APPENDIX G: BCA REPORT

Project	Raymond Terrace Bowling Club Upgrade + Hotel Development 2 Jacaranda Avenue, Raymond Terrace NSW 2300
Report	BCA Assessment Report (BCA 2022) For DA
Reference	230436-BCA-r3
Date	5/12/2023
Client	Raymond Terrace Bowling Club C/- Monteath & Powys Clint Forrester
Email	C.Forrester@monteathpowys.com.au

Figure | First Floor Plan Markup of building split | Source: EJE architectural plans

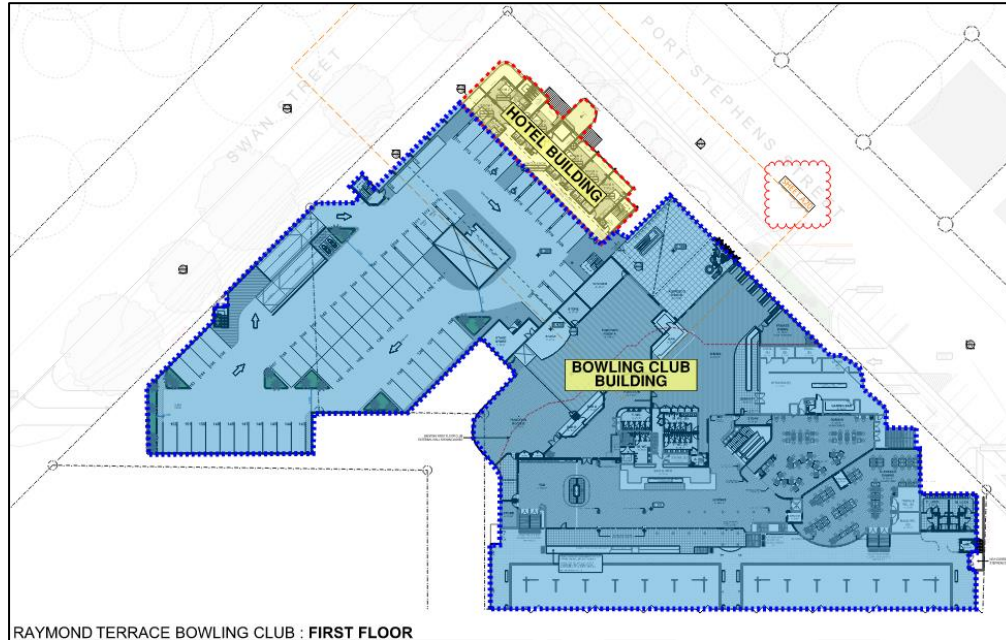
A markup of the first-floor plan below shows which areas are proposed as part of each building for the purposes of the BCA assessment.

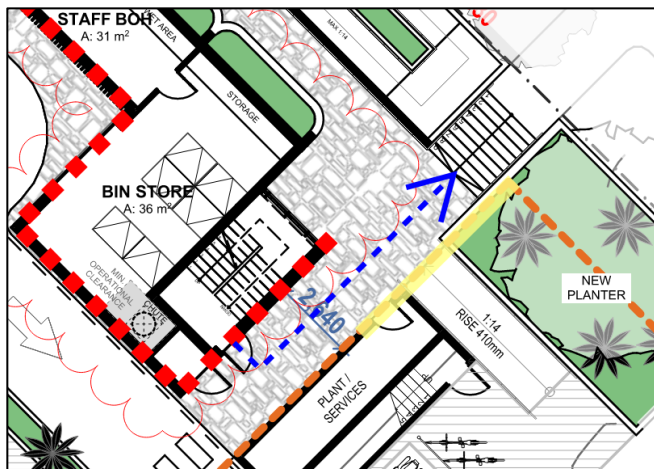
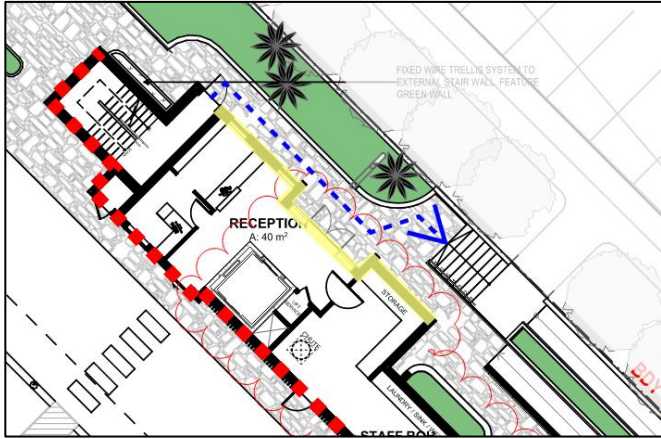
4.	<p>Protection of openings in external walls</p> <p>Clause C4D3 of the BCA specifies that openings within an external wall that is required to have an FRL, be protected in accordance with BCA Clause C4D5 if the external wall located within 3m of a side or rear boundary, or within 6.0m of another building on the allotment.</p> <p>The building is within 3.0m of the side boundary (fire source</p>	<p>C4D3 C4D5 [2019: C3.2 & C3.4]</p>	<p>C1P2 [2019: CP2]</p>

feature) in the following locations and considered to be exposed:

- Northern boundary (façade of the bowling green enclosure and change rooms)
- North-Eastern Boundary (Open carpark adjacent to neighbouring carpark)

These areas are highlighted in purple on the below diagram.

The Deemed-to-satisfy provisions are not met as due to the open nature of these structures, protection is not proposed in accordance with C4D5.
